Document Number: NA	Document Title: Briefings to LFRG on EMDF Performance Assessment and Composite Analysis		
Organization/Project: UCOR/EMDF	Comment Due Date:

Reviewer	TDEC
-----------------	------

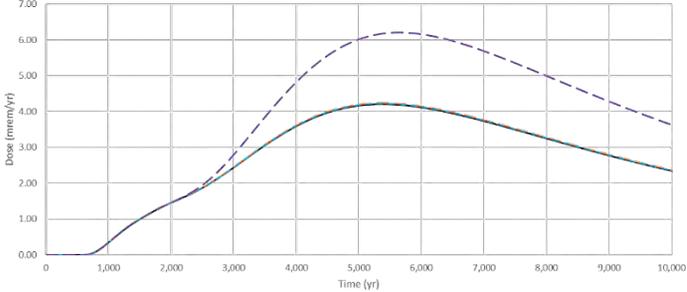
Comment No.	Presentation Slide	Comment/Suggested Change/Rationale	Response															
27	Slides 15 and 16	TFs are only considered for Tc99, not I129 or others. What is the basis for assuming I129 and others behaves the same way?	<p>Discussed September 20, 2018.</p> <p>As performed for Tc-99, additional simulations have been completed with varying transfer factors for I-129. Results are presented below.</p> <p>Refer to Sect. 3.4.5.1 of the revised PA for description of the basis for transfer factors used in the final dose analysis.</p>

<table><tr> <th>Transfer Factor</th> <th>Maximum Total Dose, Compliance Period (mrem/yr)</th> <th>Maximum Total Dose, 10,000 yrs (mrem/yr)</th> </tr><tr> <td>I-129 Meat TF: 7.00E-03 (Base Case)</td> <td>0.36</td> <td>4.21</td> </tr><tr> <td>I-129 Meat TF: 5.00E-02 (Poultry)</td> <td>0.36</td> <td>4.23</td> </tr><tr> <td>I-129 Meat TF: 4.00E-02 (Beef)</td> <td>0.36</td> <td>4.23</td> </tr><tr> <td>I-129 Meat TF: 4.4 (Eggs)</td> <td>0.36</td> <td>6.21</td> </tr></table>
